RE: **9401 Black Farms Lane**
Grading Plan
Engineer's Stamp Date 12/27/17
Drainage File: C13D027C

RE: **9401 Black Farms Lane**
Grading Plan
Engineer's Stamp Date 12/5/17
Drainage File: C13D027C

Based on the information provided in your submittal received 12/5/17, the Grading Plan cannot be approved for Building Permit until the following are addressed:

<div>ENGINEER'S SEAL</div> <div></div> <div>12/27/17</div> <div>DAVID SOULE P.E. #14522</div>	9401 BLACK FARM LN, N.W.	DRAWN BY WCVJ
	GRADING AND DRAINAGE PLAN	DATE 12-27-17
	 1606 CENTRAL AVENUE SE SUITE 201 ALBUQUERQUE, NM 87106 (505) 872-0999	21811-LAYOUT-10-16-17 SHEET # — JOB # 21808

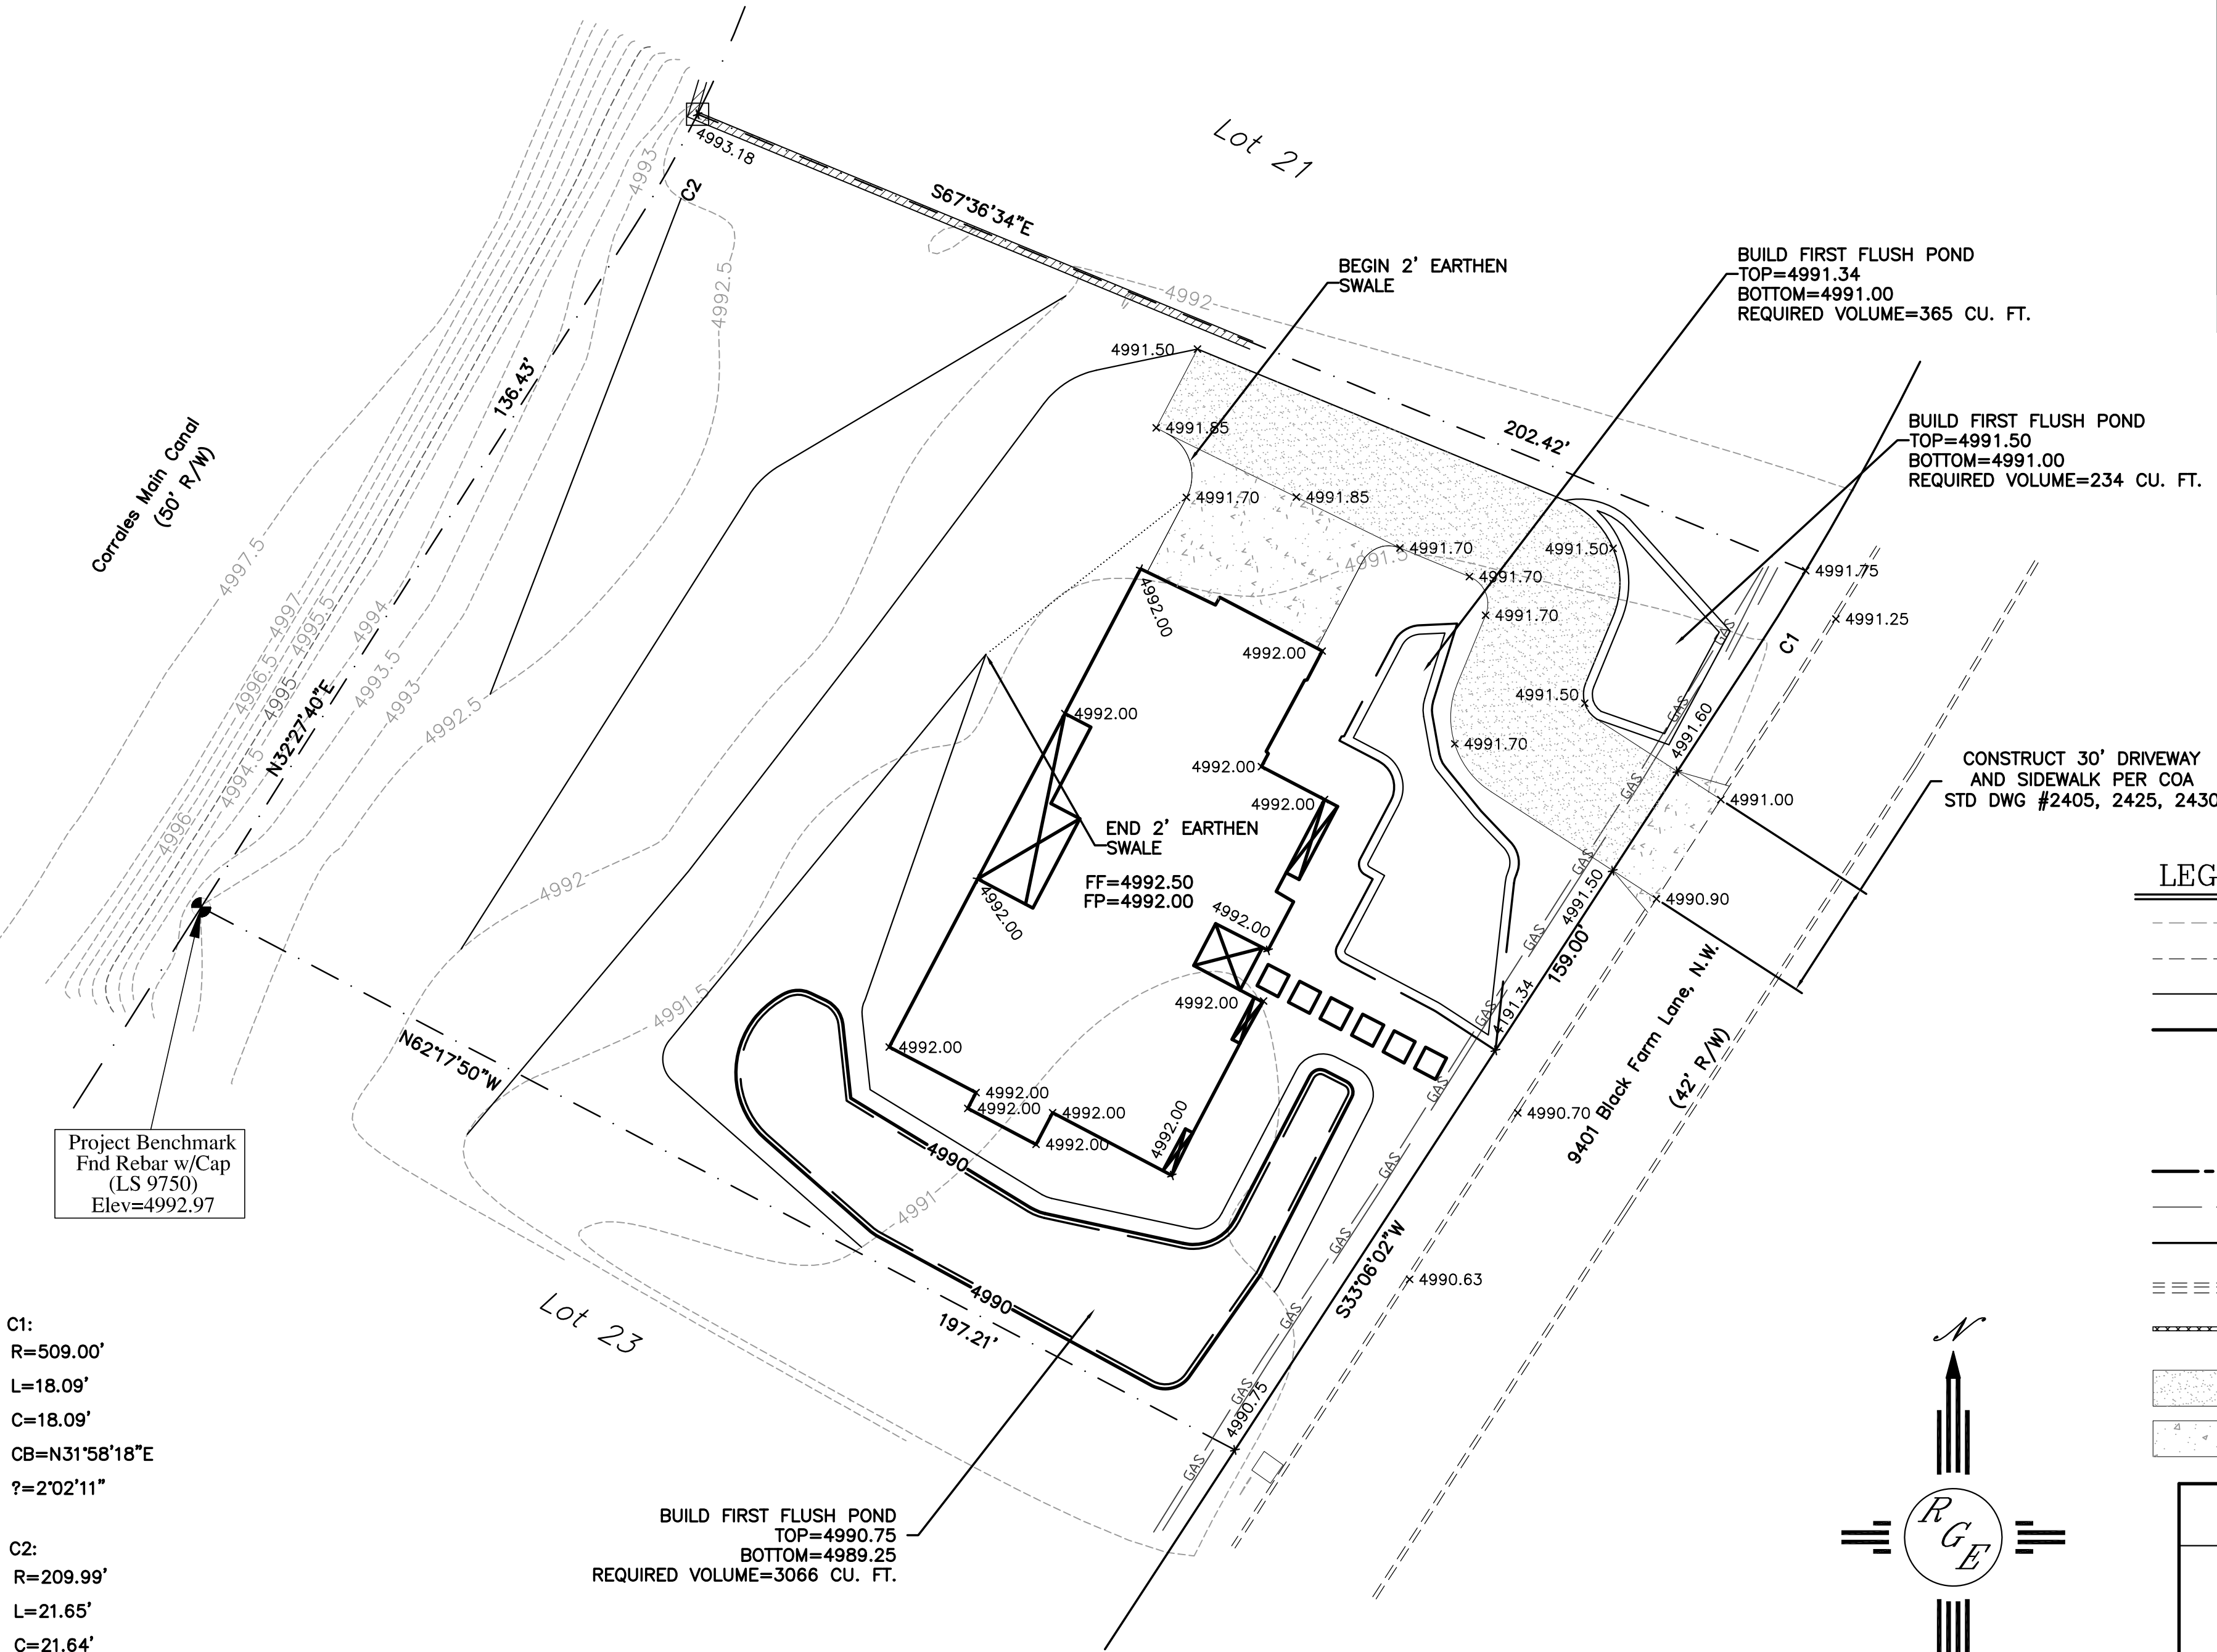
1. The approved Master Plan for Black Farms subdivision (C13D027) requires onsite retention of the developed 100-yr, 10-day volume and adherence to Valley grading criteria. **We have revised plan to retain the entire 100-year 10-day volume onsite**
 2. Ponds called for in the Master Plan were not built as part of the subdivision construction and will need to be built with each building permit.
This slope drains west to east so pond were placed at the low side (in front) rather than in rear
 3. It is recommended that the finished floor be elevated at least 1' above surrounding grades.
We have elevated the house so the pad is 1' above the average grade and 1' above lot overflow
- If you have any questions, please contact me at 924-3695 or dpeterson@cabq.gov.
